Groundwater & Wastewater Services
Septic Project File & Data Review Worksheet

GWS File #: 7771B WASPS App #: 3547

MECKLENBURG COUNTY GROUNDWATER & WASTEWATER SERVICES
APPLICATION FOR A RESIDENTIAL SITE IMPROVEMENT PERMIT/ CONSTRUCTION AUTHORIZATION FOR AN ON-SITE WASTEWATER SYSTEM, NEW WELL INSTALLATION, OR *REPAIR OF EXISTING WELL*

Re: Application for improvement permit for:
Property Site: 820 MARTINGALE LANE
Health Department file number: **7771B**

SOIL EVALUATION LOCATIONS FOR
820 Martingale Dr
APPLICATION

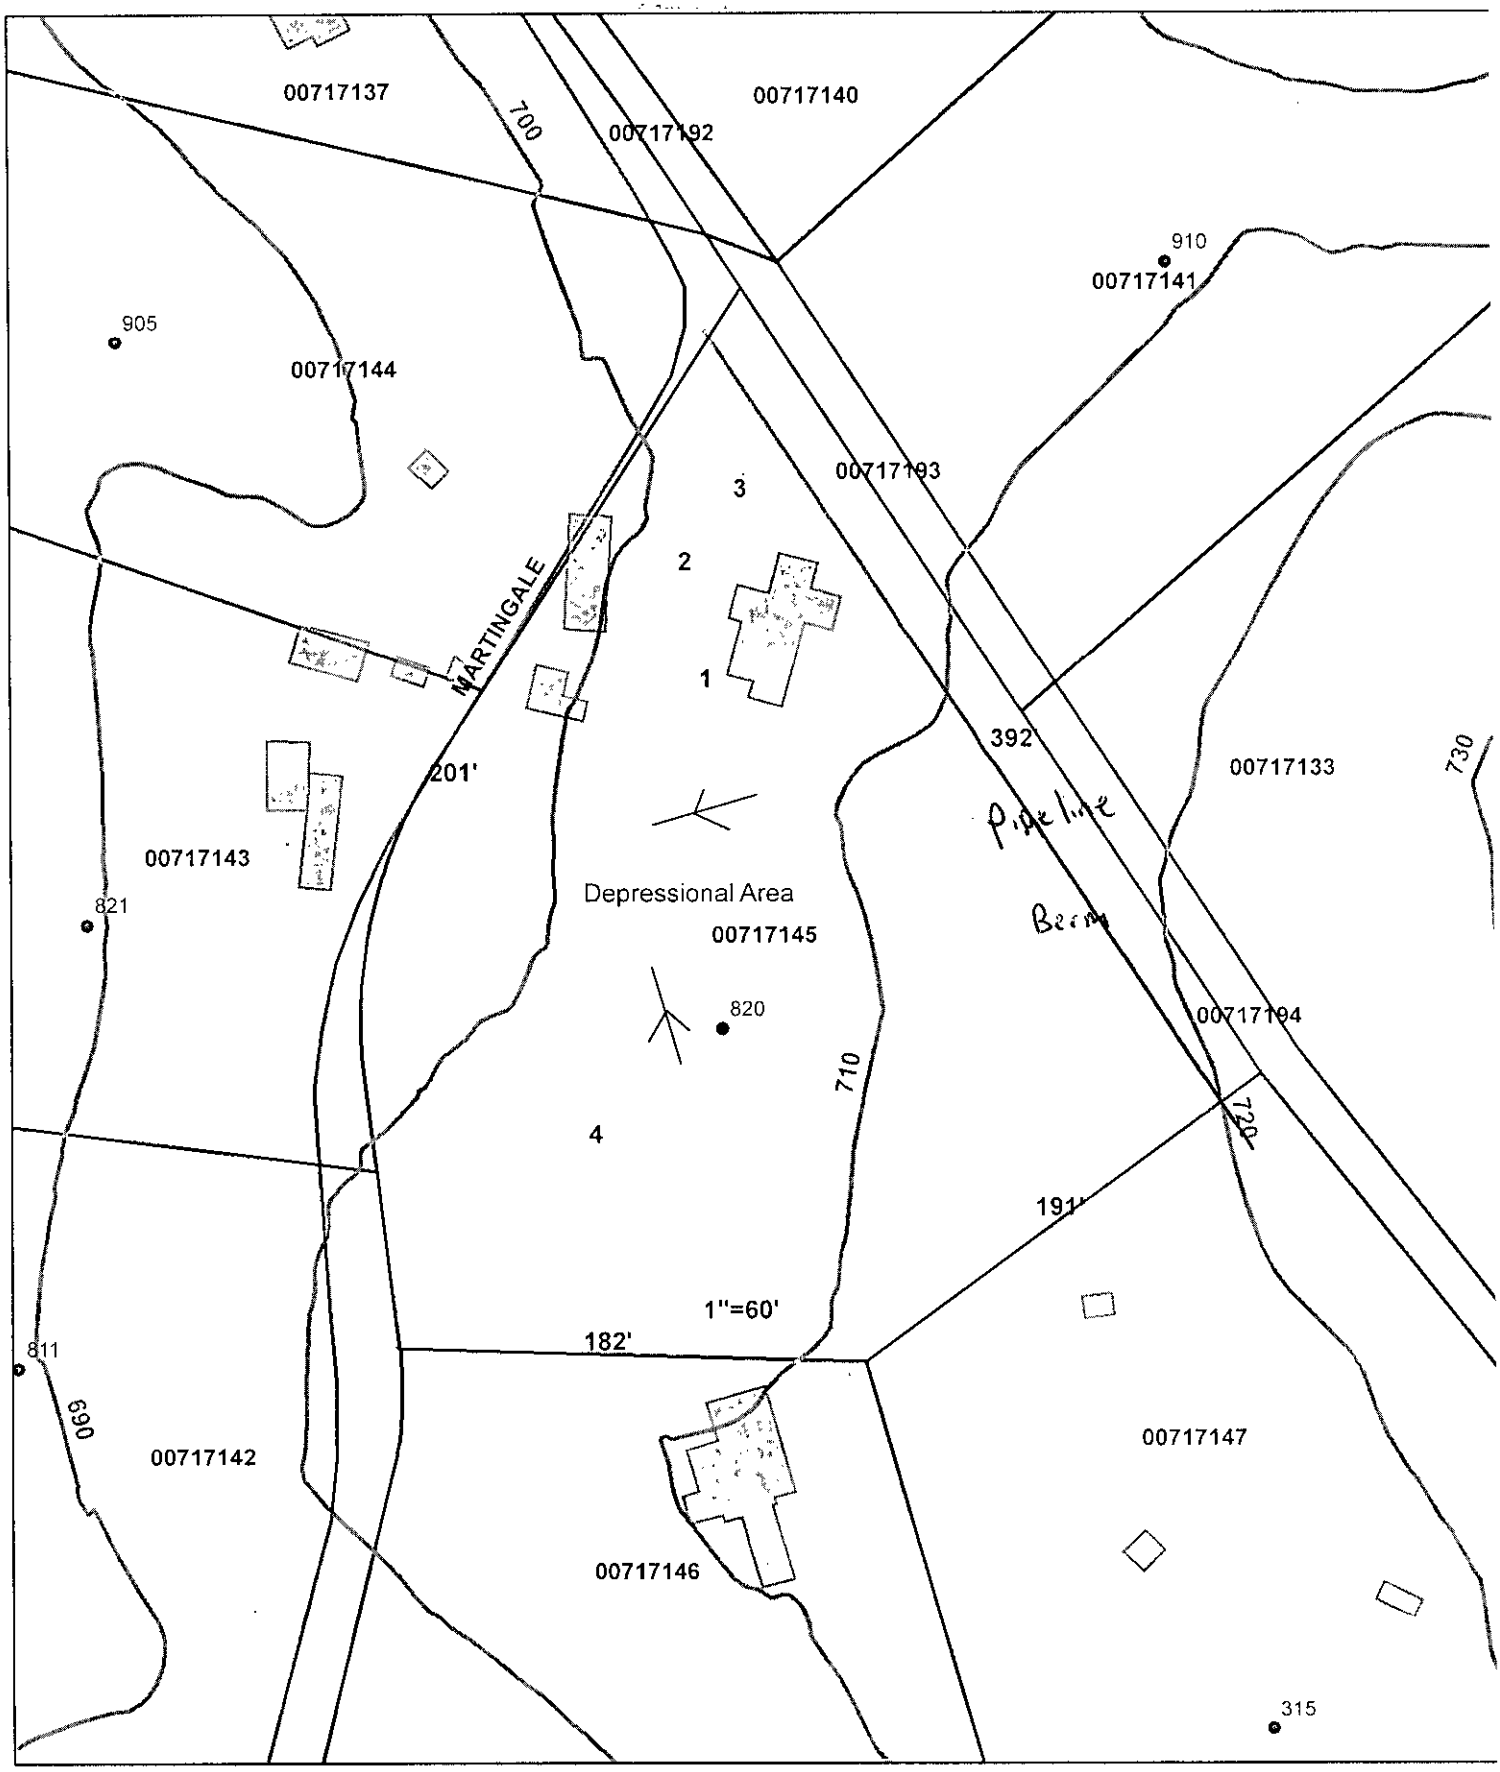
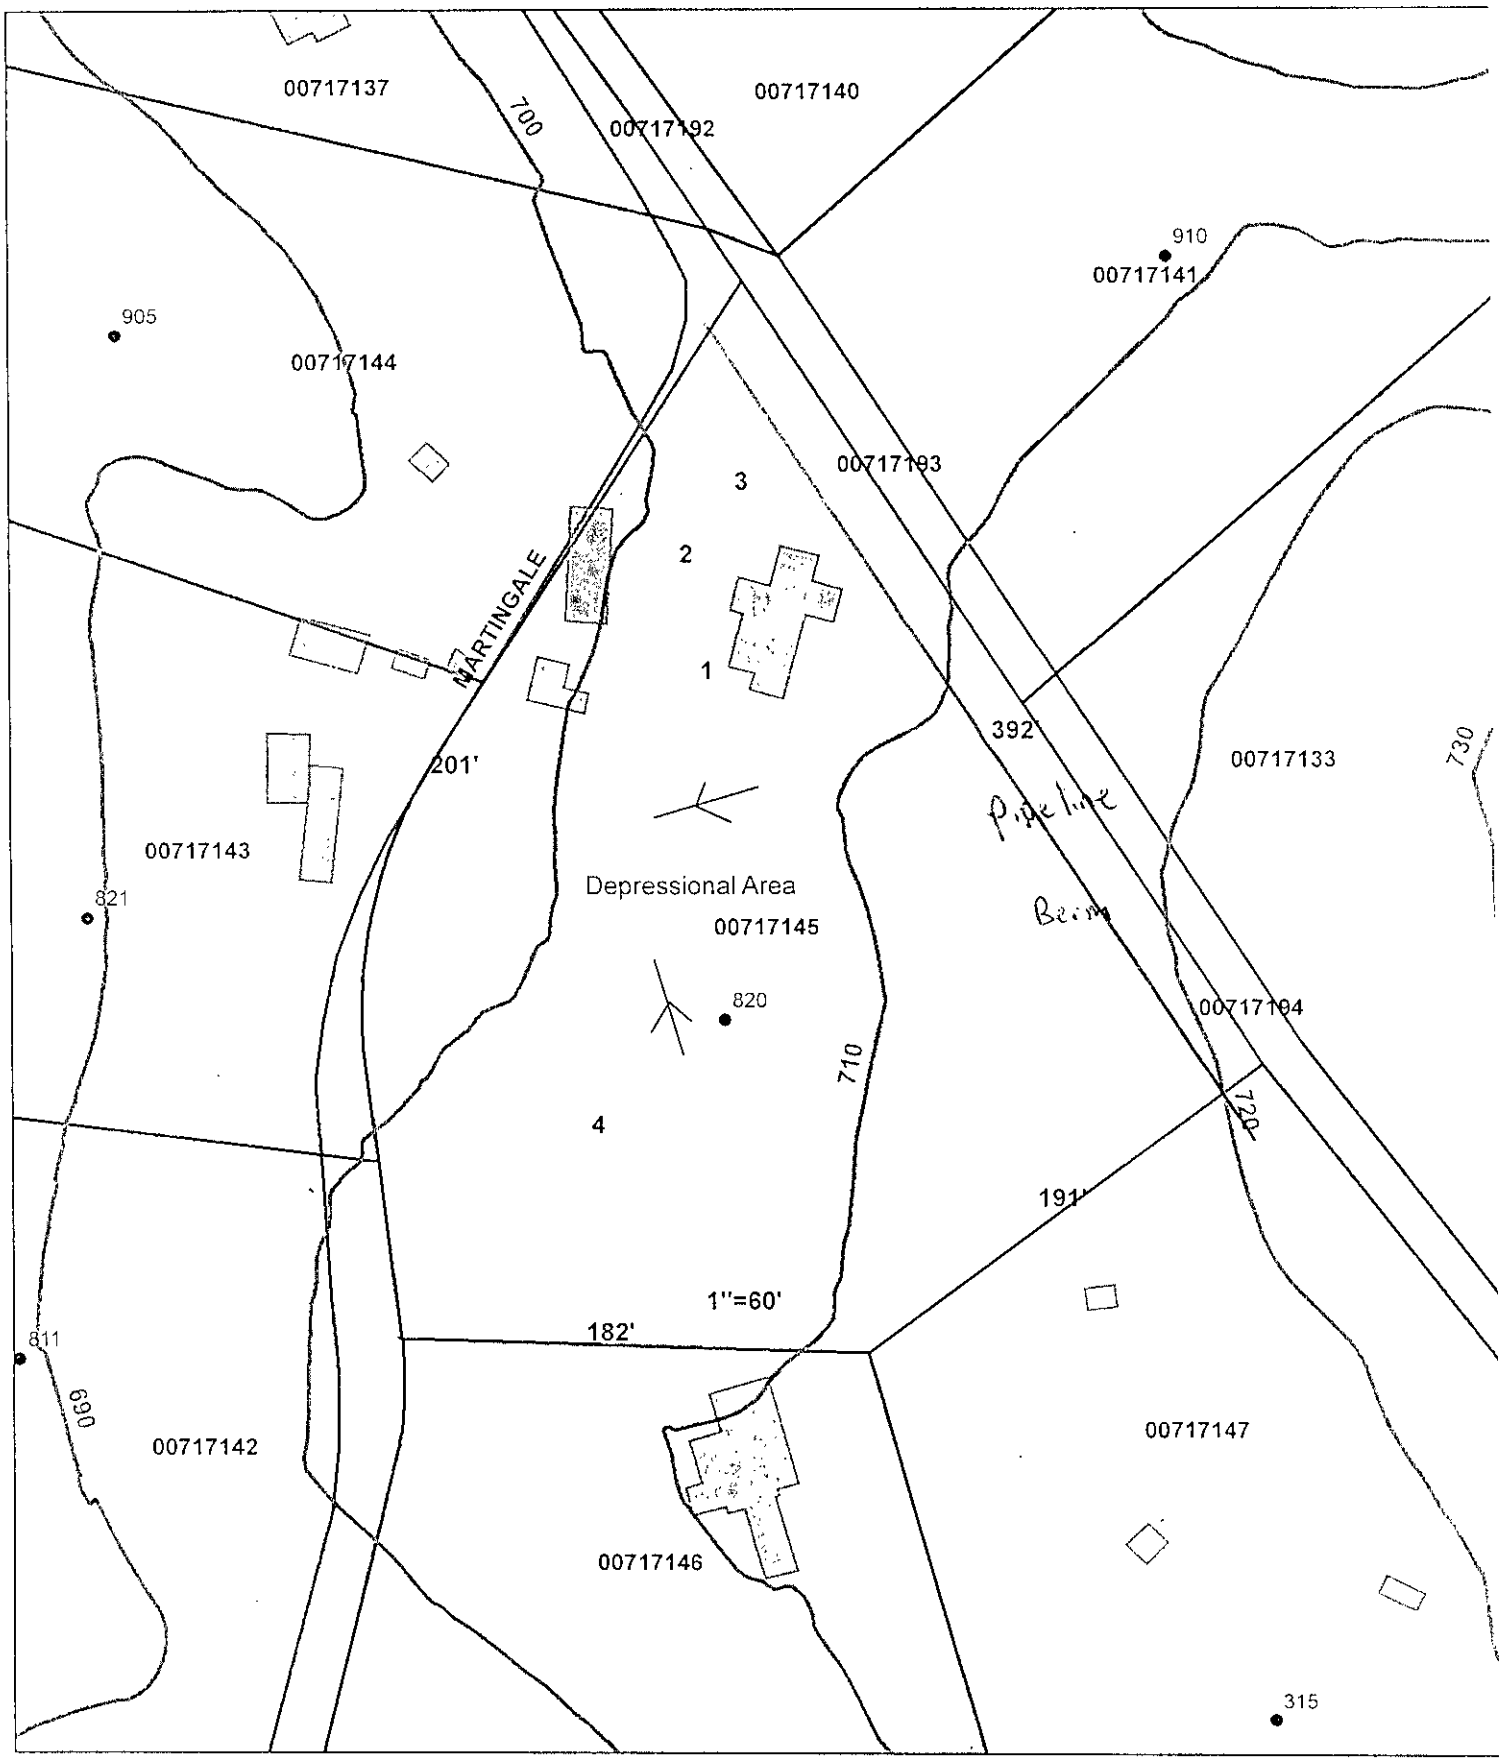
100% repair area required

Sketch of Soil Evaluation Locations

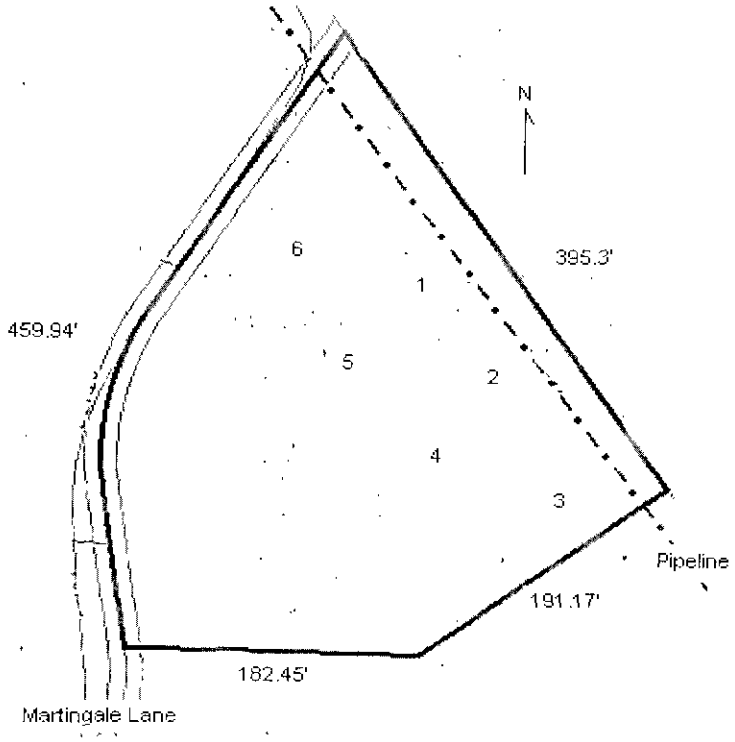
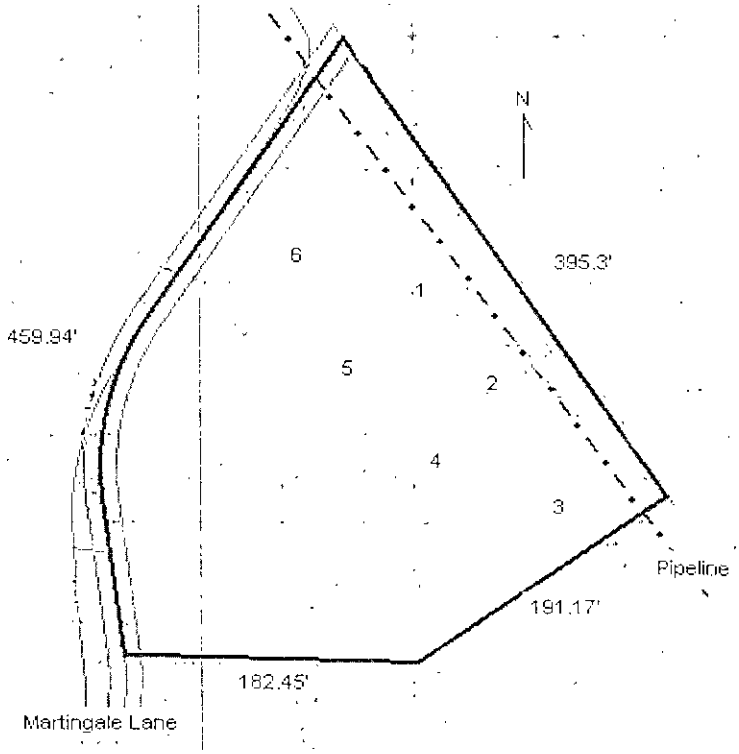
COMMENTS:
100% repair

COMMENTS:
100% repair
